Administrative Approval Action

SR-94-18 / Iglesia Nuevo Renacer
Transaction# 570694 AA#3944

ADMINISTRATIVE SITE REVIEW IGLESIA NUEVO RENACER 4400 PEARL ROAD RALEIGH, N.C.

SR-94-18 TRANS #570694

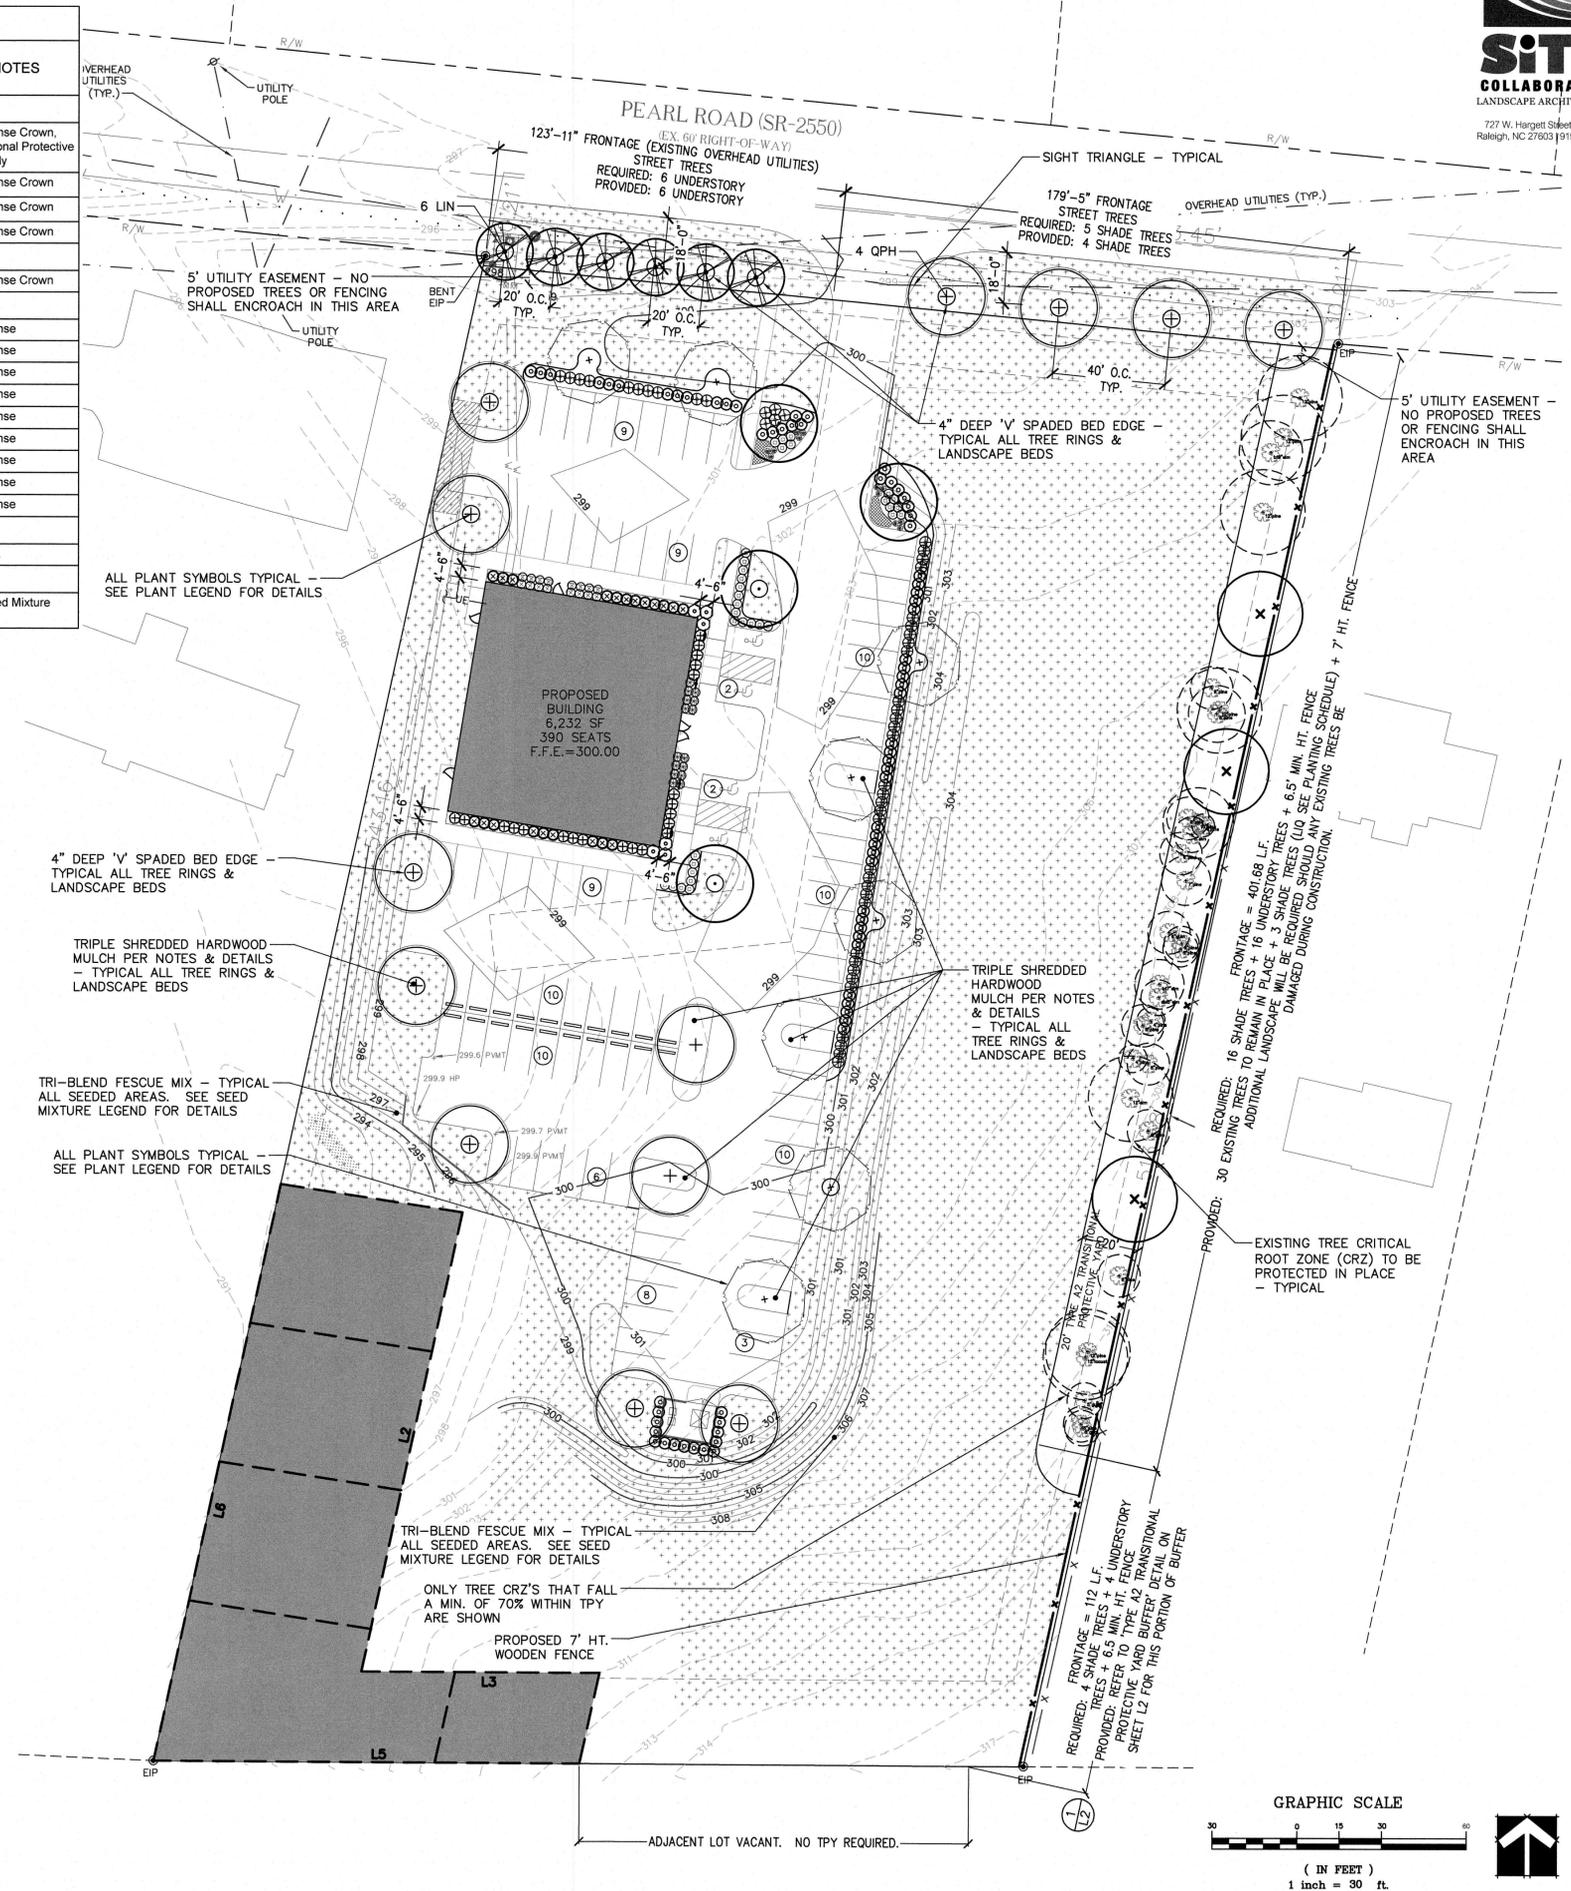
1. A final tree inventory count and detailed planting schedule table for the “existing trees” shall be provided and shown, per the note on sheets L-1 and L-2 of the landscaping plan stating the “30 existing trees will remain in place” & “canopy tree(s) to remain in place”; which are being used to meet the required Type A2 Transitional Protective Yard (per Sec.6.3.1.E & Sec.7.2.4). The existing trees must meet the required design & installation standards noted in Sec.7.2.7 and noted on the table.
